***Request for Contribution for Refining  
the Seamless Redundancy Concept  
Presented in San Diego***

*(Version Date: September 4, 2012)*

**Markus Jochim, General Motors Research & Development  
Oliver Kleineberg, Hirschmann Automation & Control**

Comment 1: “Redundancy management in bridge (Time constraints in fast path)”

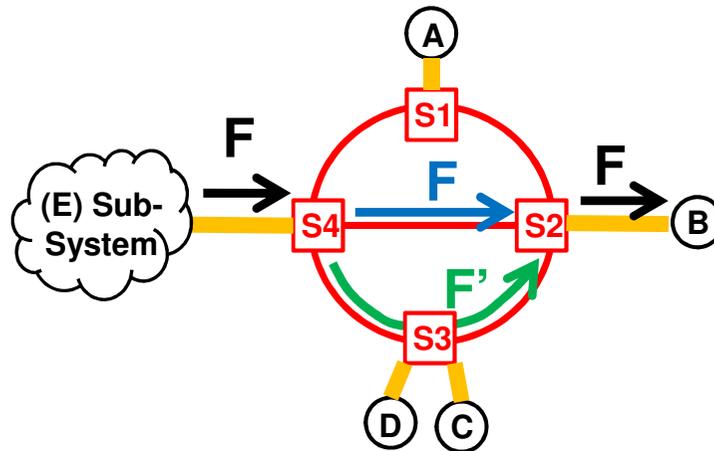
According to slide 25 of [1], the bridge executes the redundancy management function that eliminates duplicates. This is difficult since the function would need to be executed in the fast path and in the fast path there is probably not enough time to execute the function. Evaluate the option to execute the redundancy management function in the listener instead!

- If the listener executes the redundancy management function, both messages F and F' have to be forwarded from S2 to B. The link may become be a bandwidth bottleneck.
- Depending on the complexity of the network and the number of redundant paths, the bottleneck problem may get worse and network design flexibility can suffer.
- Even if integrating redundancy management functions into the bridges is challenging, lightweight duplication elimination techniques (like a multiple sliding /drop window algorithm) could be used – especially if seamless operation is only considered for scheduled traffic

We believe it is worth to start out by collecting some opinions on which solutions within bridges might work.

## ***Response to comment #3 (Slide 1/2)***

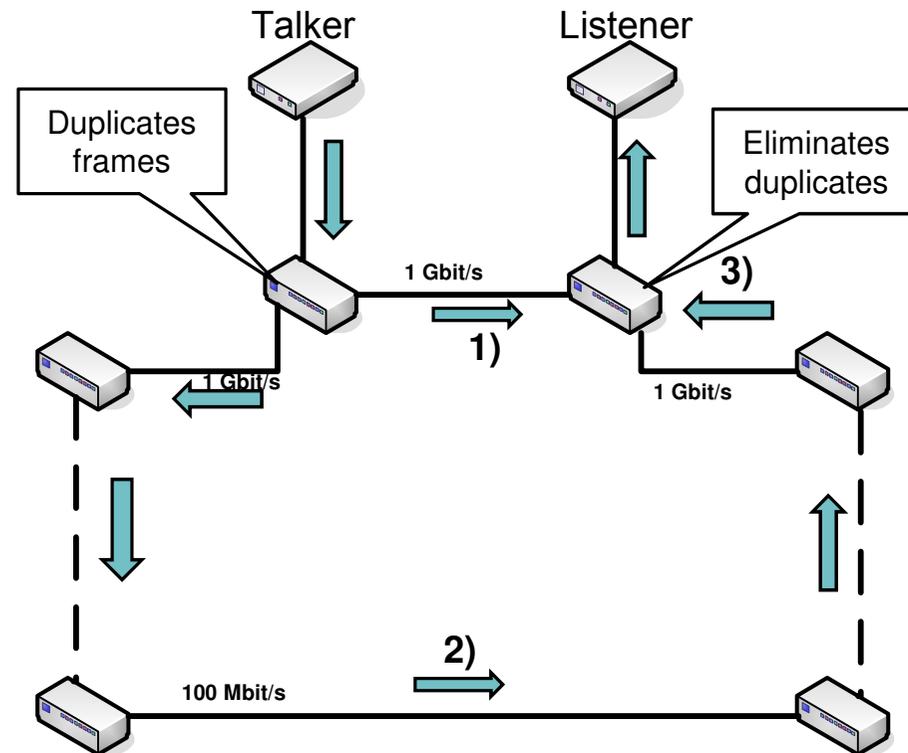
a) In the diagram on slide 24 of [\[1\]](#) the frames F and F' may arrive at S2 at different points in time. How do we address this problem especially in scenarios where the frames arrival times may differ quite a bit (e.g. because the links in the topology are operated at different speeds).

- One possible constraint introduced could be the restriction of only allowing redundant paths to have the same link speeds.
- There will always be a certain difference between the frames from F and F'... the redundancy management (in this case the duplicate elimination procedure) must be designed in a way that it can detect duplicates within the worst case time difference between F and F'

If we assume that differing link speeds on different paths, in respect to redundancy, result in different max. latency, the problem is reduced to handling the time difference between the arrival of F and F'. Bandwidth implications will be handled by SRP.
